**Re: Interagency Consultation: SR 202L - Val Vista Drive to SR 101L, 202-C(208)T | 202L MA 44 F0124 01C**

Project Level CO Quantitative Hot-Spot Analysis – Consultation Document

Response to EPA Comments on F0124 CO and PM Consultation Documents (red)

Response to FHWA Comments on F0124 CO and PM Consultation Documents (red)

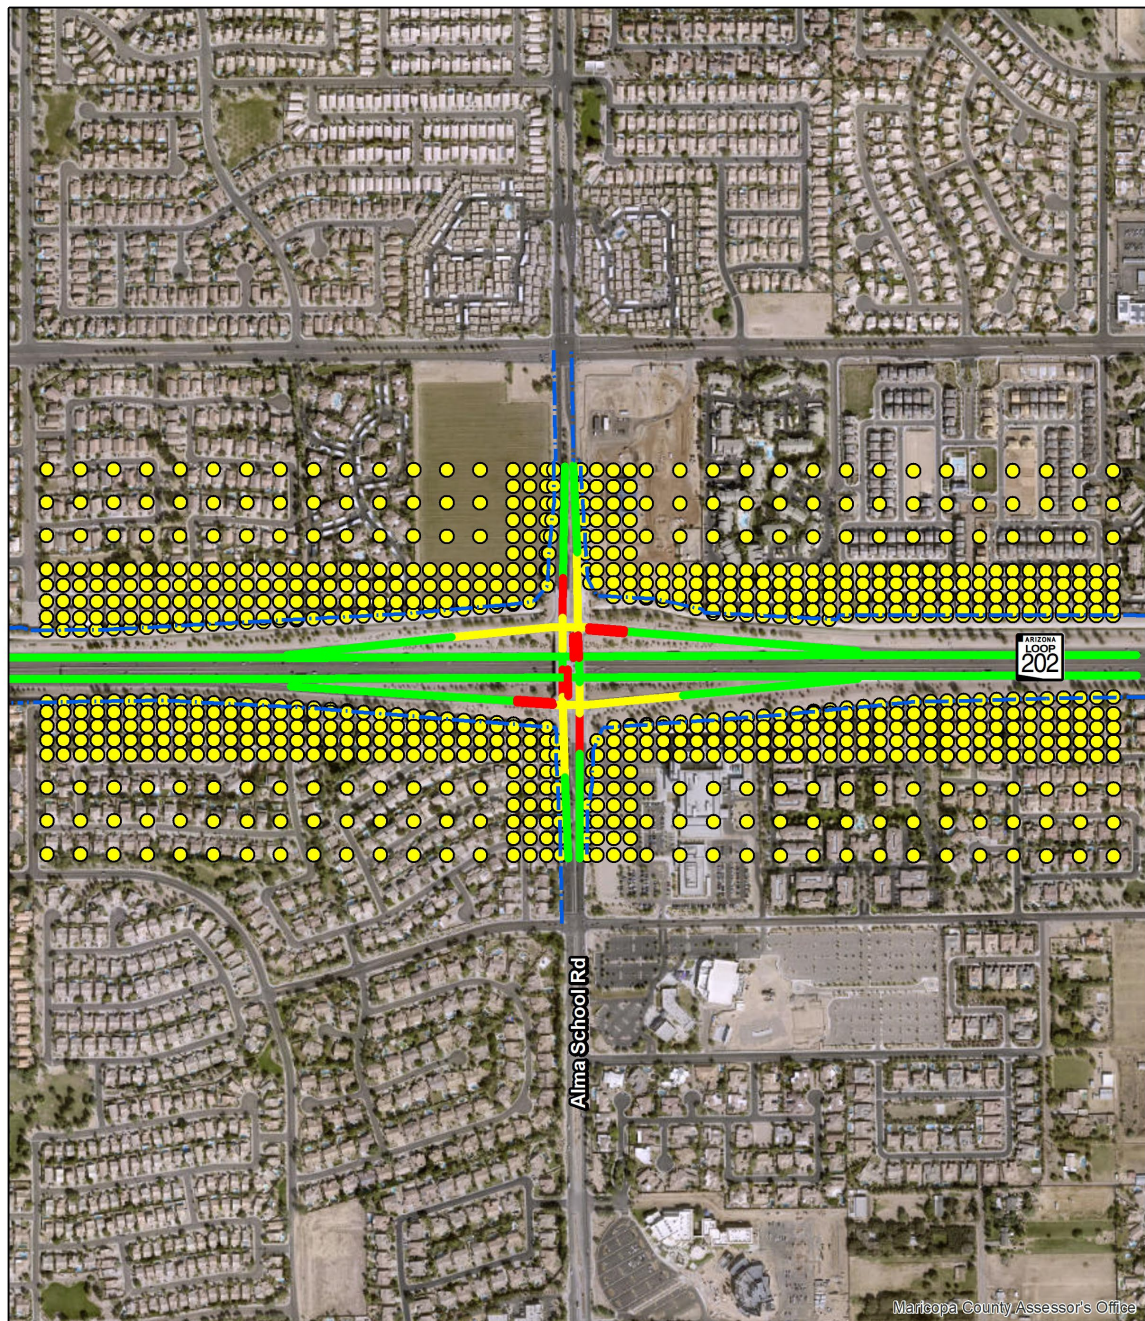
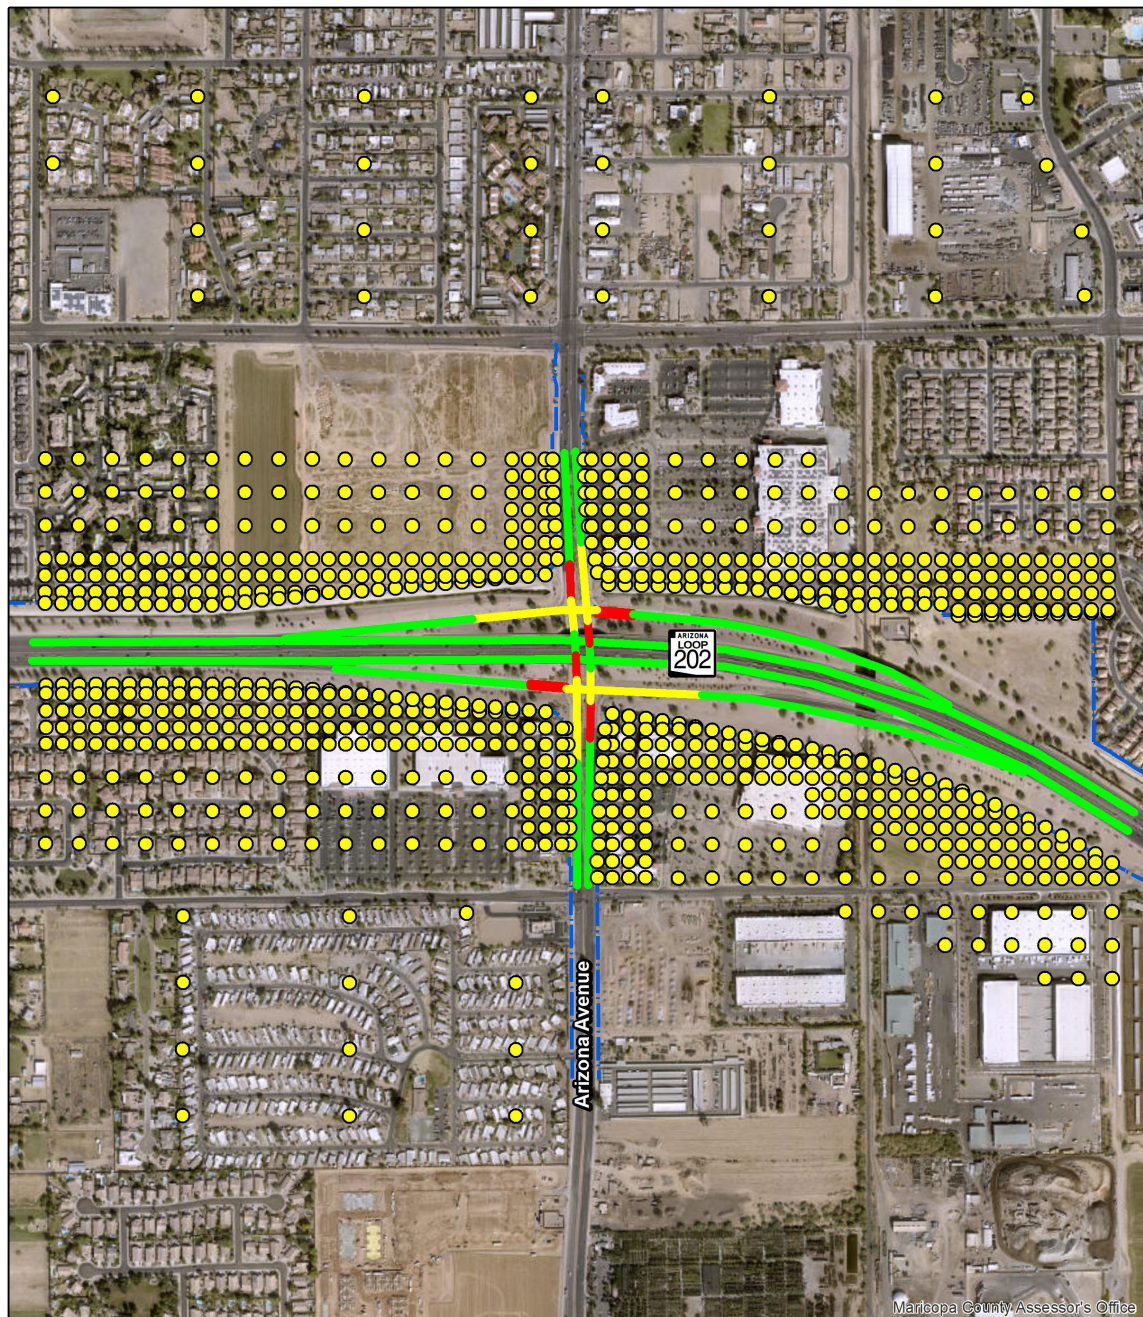
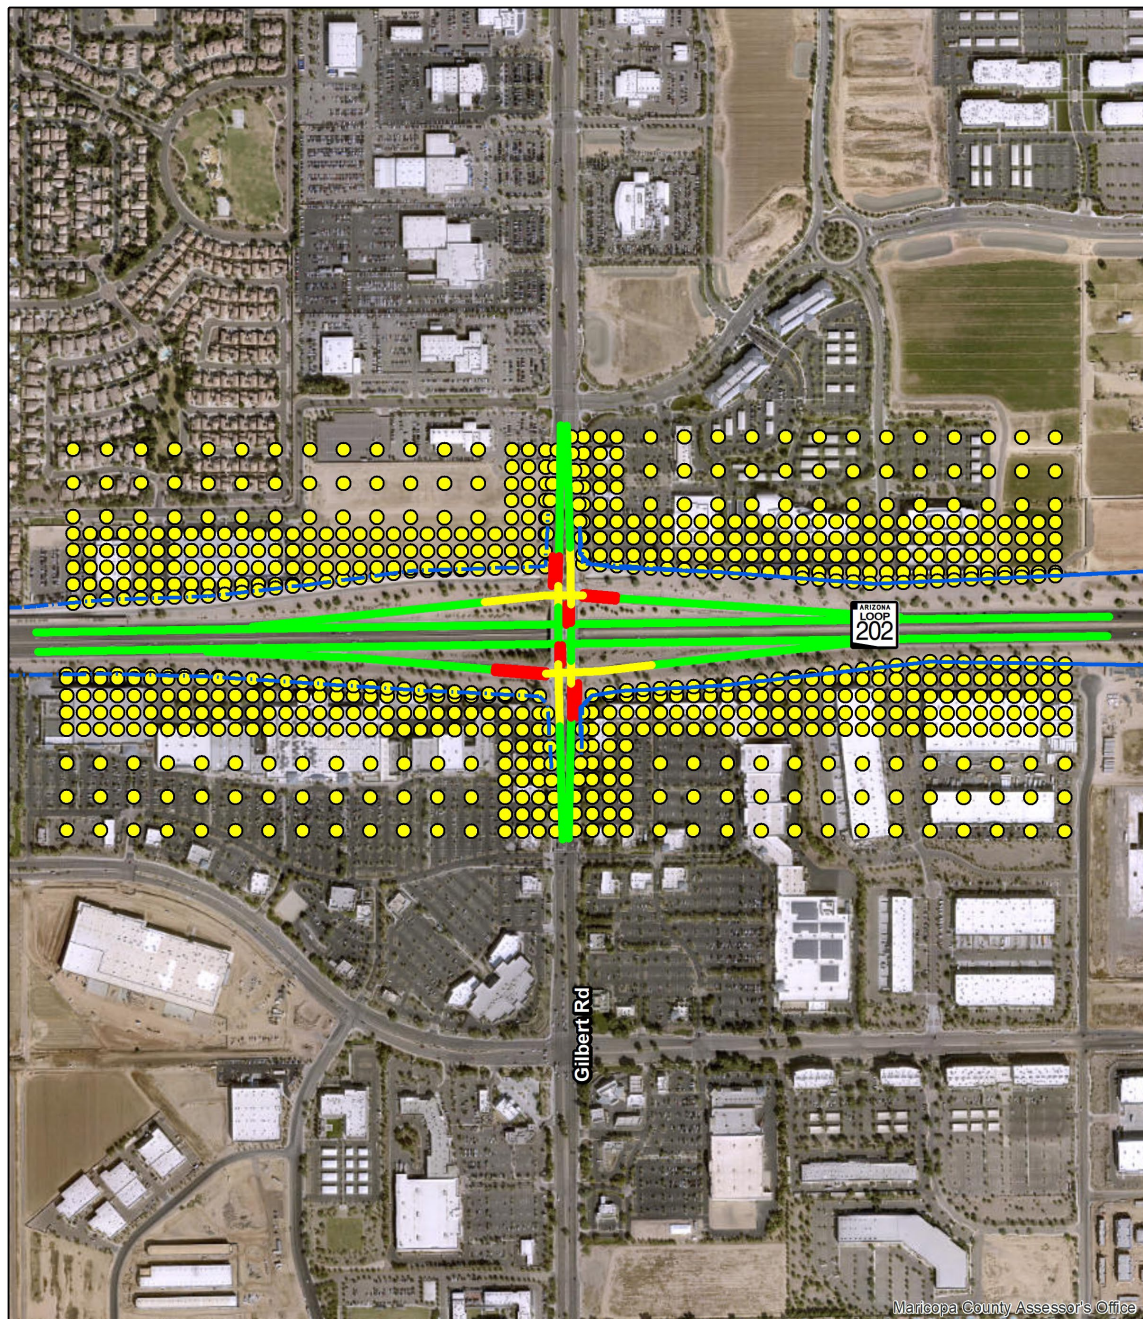
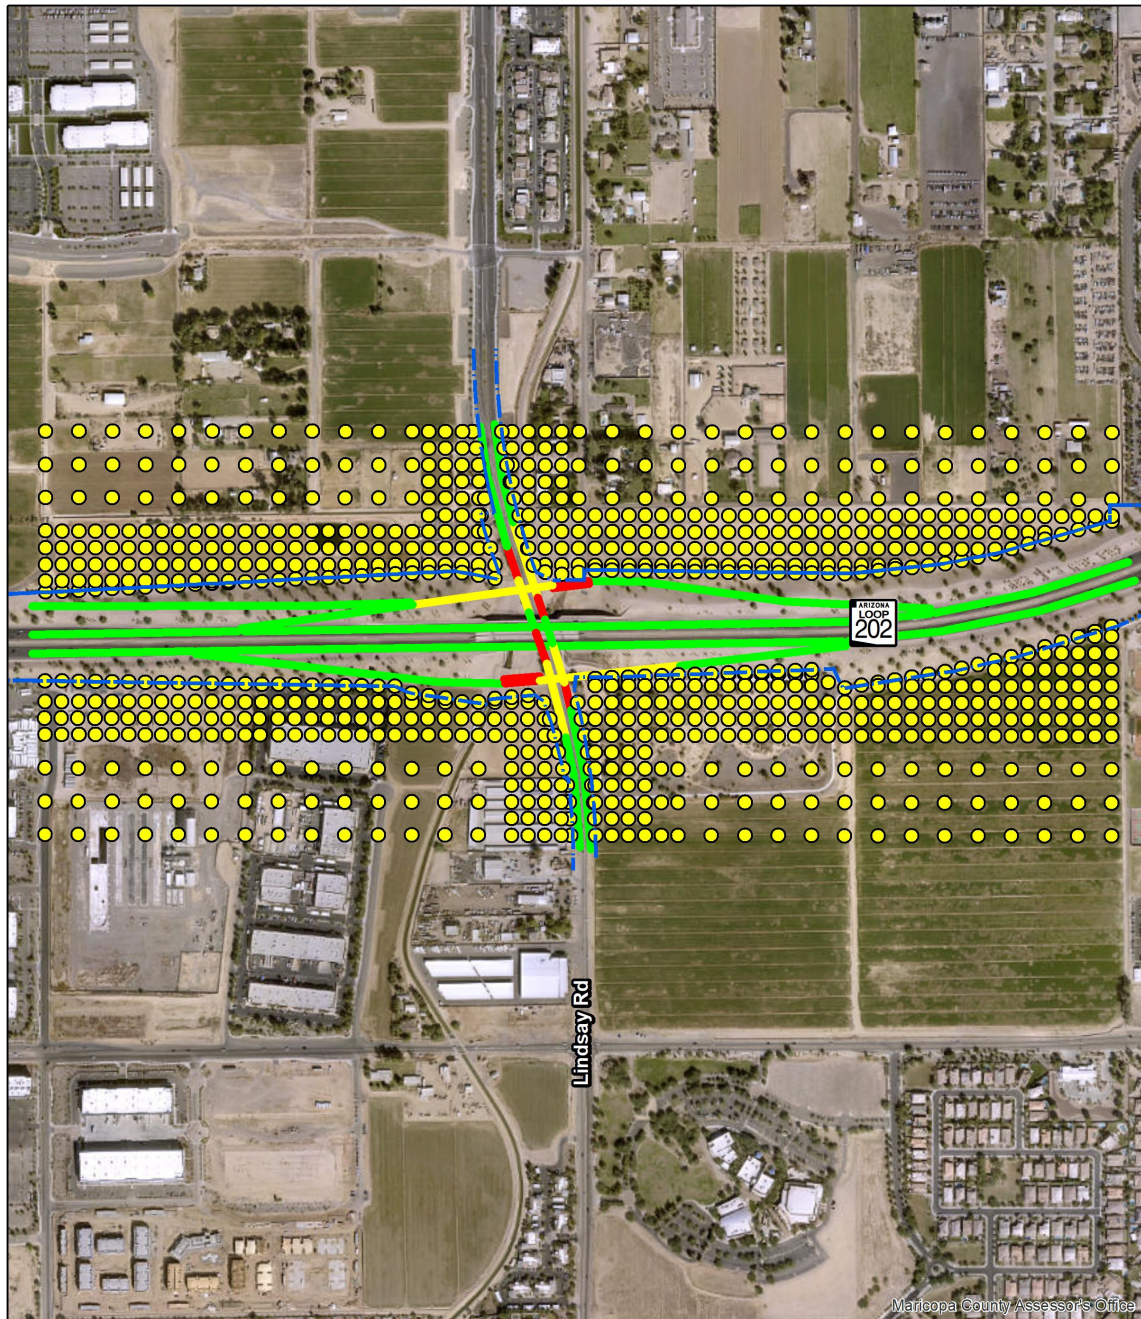
- 9) Table 2, Step 5, Receptors (RE Pathway): Some receptors appear to be more than 25 meters apart. Please change the receptor spacing to be 25 meters apart if they are further than that. Furthermore, please verbally describe the spacing of the receptors as Figures 2 – 4 show some receptors more densely packed than others.

The receptor placement is consistent with the guidance. We placed the receptors along and outside ADOT ROW. Additional receptors were placed at 25 meters for several front rows near the roadway sources per comment (additional 305 receptors for Alma School Rd TI, additional 261 receptors for Arizona Ave TI, additional 272 receptors for Gilbert Rd TI, and additional 312 receptors for Lindsay Rd TI). the highest PM concentration would normally occur at receptors near the roadway sources. the PM concentrations would decrease further away from the roadway sources, and receptor placements further away from the source would not affect the highest PM concentration design value for the intersection and analysis results.

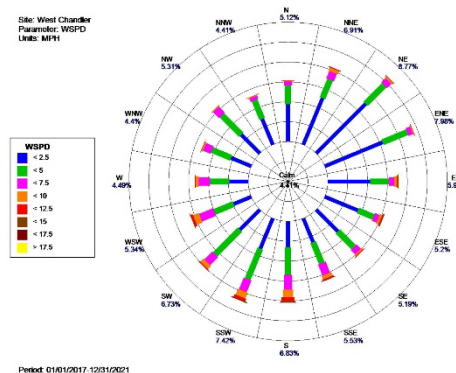
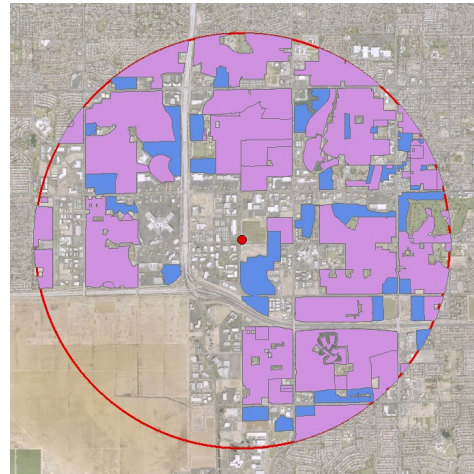
- 6) Table 1, Background Monitor: Please explain in more detail why the CO monitor at Frye Rd and Ellis St in West Chandler is chosen for the background concentration. This monitor should be representative of background concentrations at the project area. Although some data are provided on pages 17 and 18, it would be helpful to explain how these data support the use of this monitor as an appropriate background monitor.

Percentages were added to the land use/terrain row below. Wind rose figures were added in the Wind pattern row below, which include the wind speed in each direction and wind percentages for each wind direction.
